SHEET NAME & NO.  
GRADING AND  
DRAINAGE PLAN

C-102

**Re: New Training & Storage Facility  
421 Arizona St SE  
Grading and Drainage Plan  
Engineer's Stamp dated: 6-12-15 (L18D074)**

Based upon the information provided in your submittal received 6/12/2015, the above referenced Grading and Drainage Plan cannot be approved for Grading Permit or Building Permit until the following comments are addressed.

A1 GRADING AND DRAINAGE PLAN  
SCALE: 1"=10'

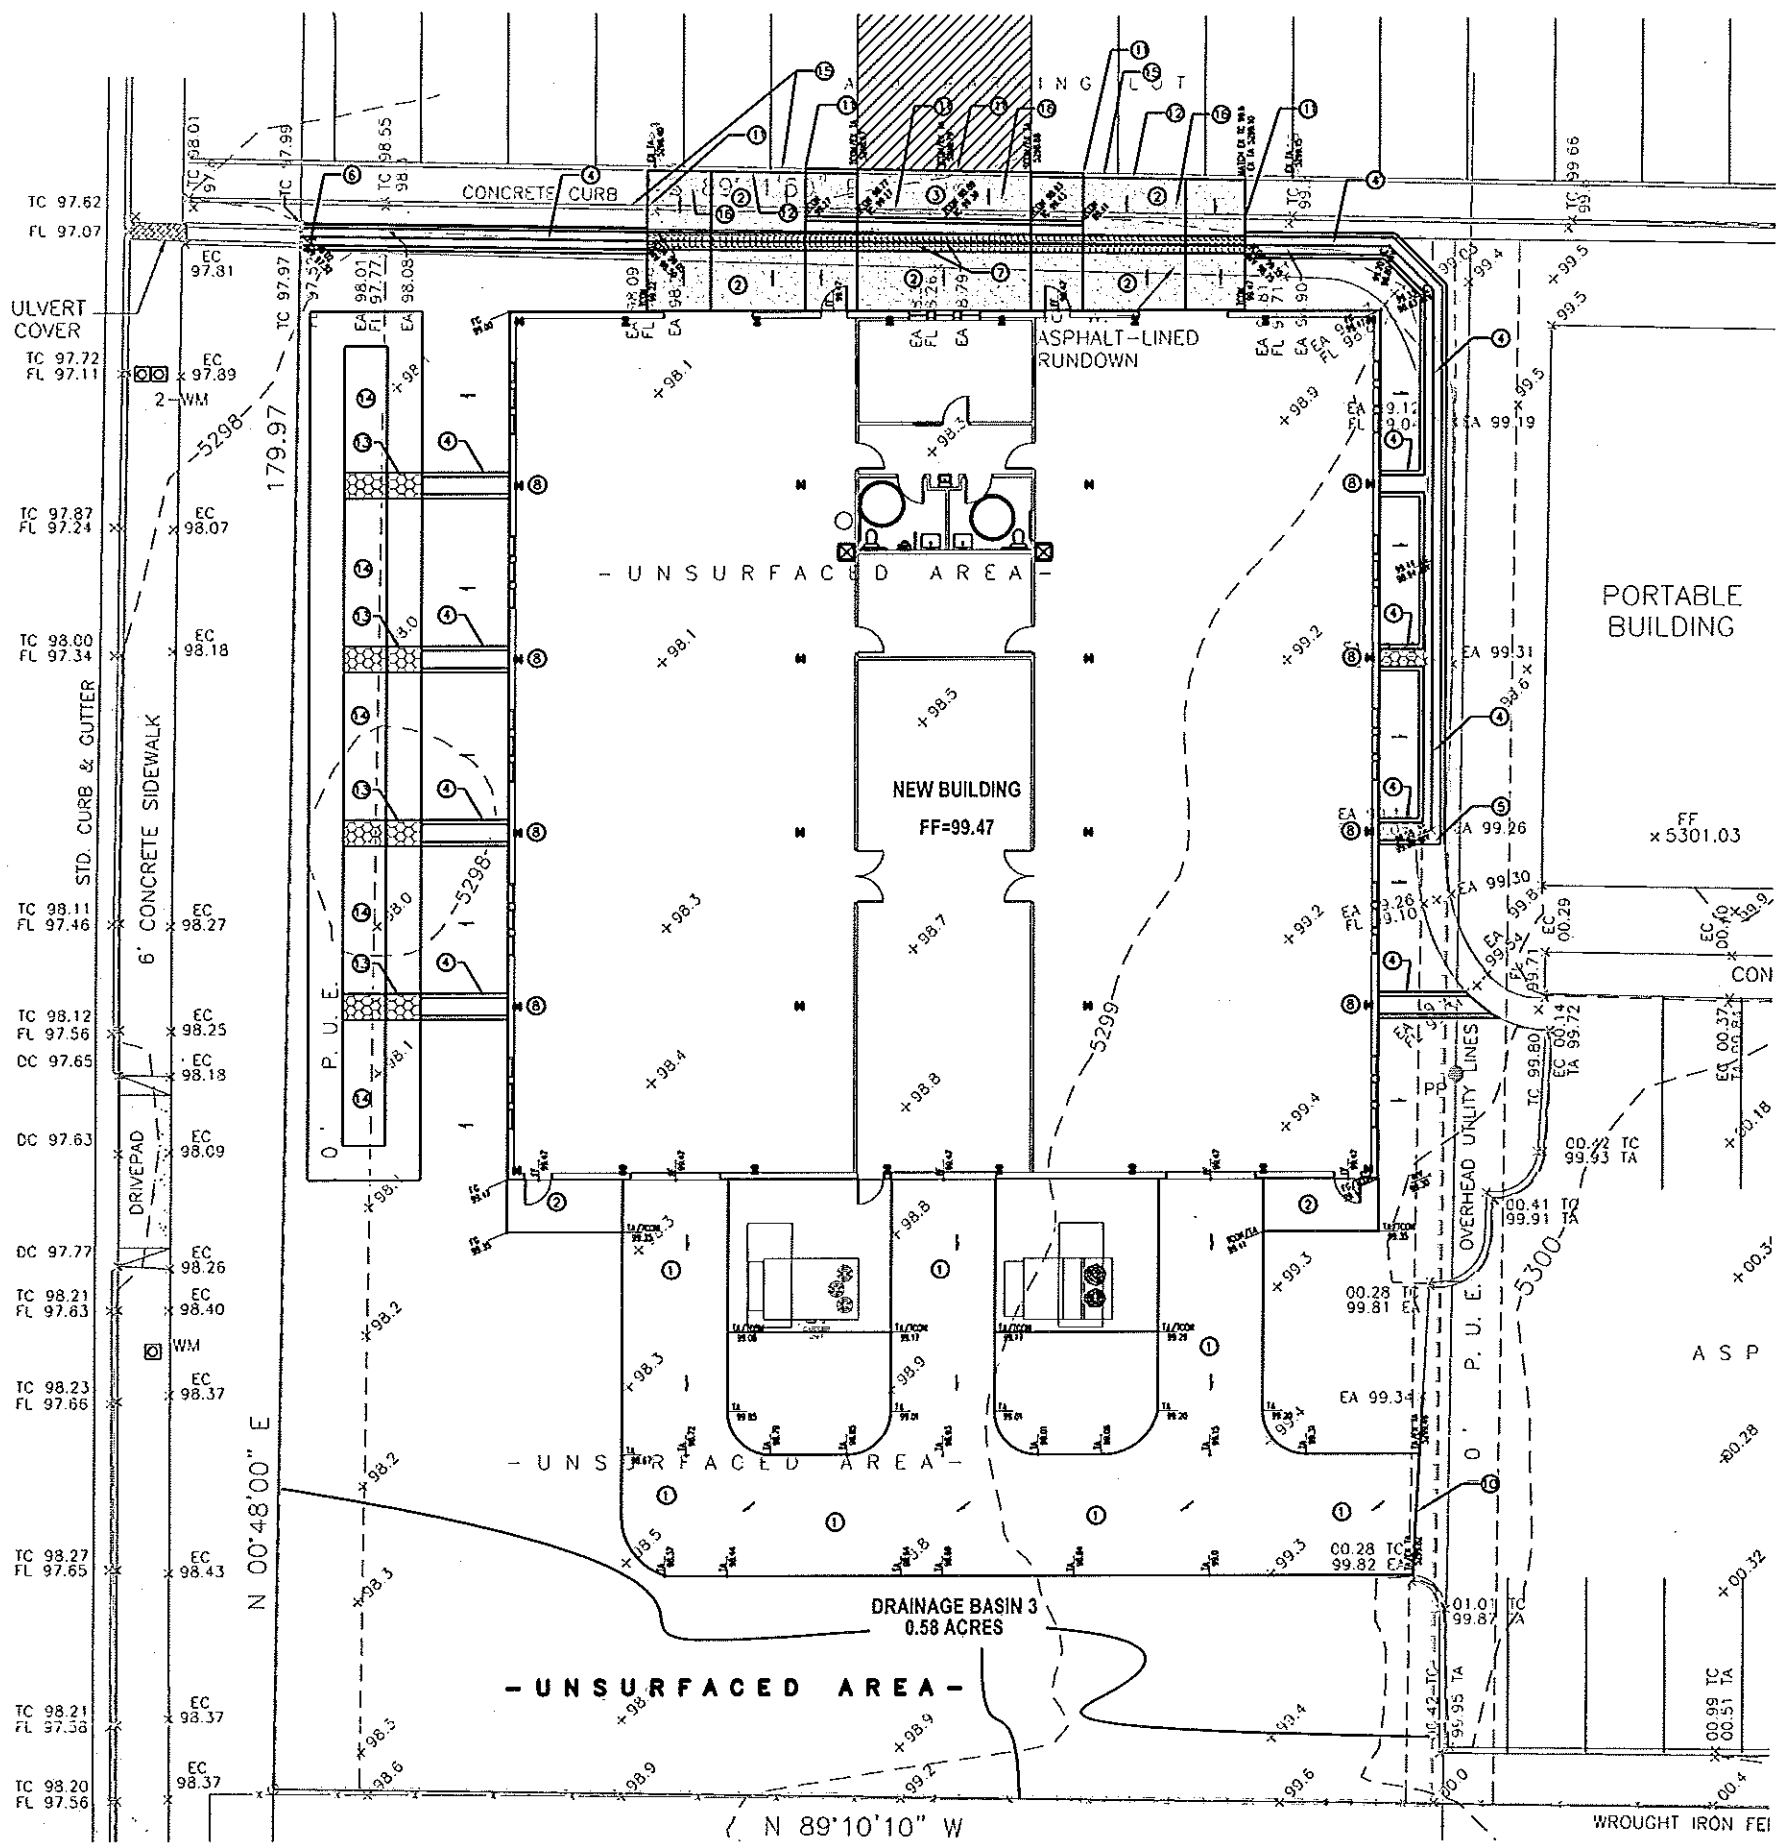
- Provide how flows are leaving the FF pond. What is the pond bottom?
- Provide the type of surface in the south area. A look at the aerial map shows pavement. How will the flows exit this area?
- Provide a FF pond for the downspouts on the east side of the building.
- Provide a letter of approval from the owner to the north of this site for grading and paving in their property. Also provide a FF pond for this area. What does the hatched area represent?
- Sheet C-501 shows a typical pond section with a berm. Where is this berm located? If on the east side of the pond, how will the concrete channels enter the pond?
- Provide a basin map of the entire area.
